The voice of the European generating set industry

EUROPGEN Contribution to NC RfG Amendment Proposals

25th October 2022

Example: Power generating facility with 5x 3MW SPGMs

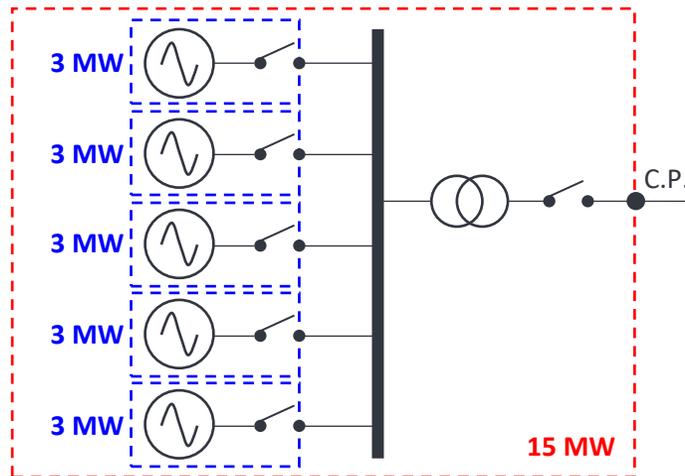
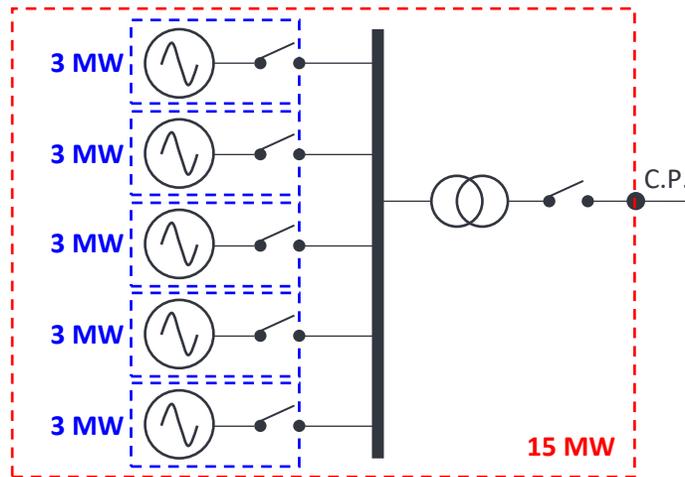
Issue: There is **significant inconsistency** on how determination of significance is defined for SPGMs.

This results in **disproportionate requirements** for SPGMs relative to their individual effect on the overall system.

Country A:

SPGM type classification based on **individual unit rating**

Each SPGM is considered **Type B**

Country B:

SPGM type classification based on aggregated capacity of the facility

Each SPGM is considered **Type D**

Proposal: Amendment to Preamble (9), Article 2(9), and Article 5(1) to clarify how the SPGM definition should be applied. The principle from Preamble (9), which states that individually run synchronous units must be classed on the machine size (and not the whole capacity of the facility) should be upheld.
